Glacial Waters Subdivision Camp Addition KPB File 2023-125 Peninsula Surveying, LLC / Camp Kenai, LLC Location: Eaglet Way Funny River Area / Funny River APC

ITEM #2 - PRELIMINARY PLAT Glacial Waters Subdivision Camp Addition

KPB File No.	2023-125
Plat Committee Meeting:	December 11, 2023
Applicant / Owner:	Camp Kenai LLC, South Carolina
Surveyor:	Jason Schollenberg / Peninsula Surveying, LLC
General Location:	Eaglet Way & House Drive in Funny River APC

GLACIAL WATERS SUBDIVISION CAMP ADDITION

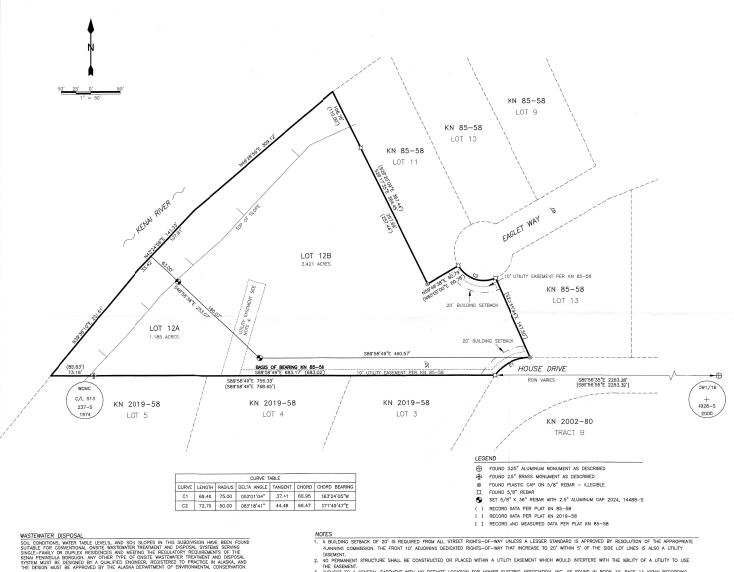
There are areas of steep grade on the west side of the subdivision near the Kenai River, that are marked accordingly. If the top of slope is also the top of bluff, surveyor should add "bluff" behind slope on the notation. The terrain of the rest of the subdivision has a gradual slope from the east towards the river on the west.

There are no classified wetlands, the plat note regarding wetland determination is present and can remain. The area is in a flood hazard aera as designated by FEMA maps and noted by the River Center below, appropriate plat notes for flood hazard should be added. **Staff recommendation**: place a note on the final plat indicating any person

Glacial Waters Subdivision KN 85-58 granted 10' Utility Easements on both right-of-ways and both side lines coming from House Drive. *Staff recommends*: the easement on the east line be added to the drawing.

Remove SE1/4 from legal as Lot 12 is into the SW1/4 NE1/4 also.

Reduce scale for better visibility.

- Plat note 8 needs the date of December 11, 2023 added upon approval of the exception to KPB 20.30.190. Add KPB in front of 20.30.190.

- Add to plat note #5 "2023" in front of field measurement.

Add date of December 11, 2023 to Plat Approval.

Change name of Delores Snelgrove Stround to Franklin Eugene Friddle, Jr.in the Certificate of Ownership and Dedication signature line and in the Notary Acknowledgement.
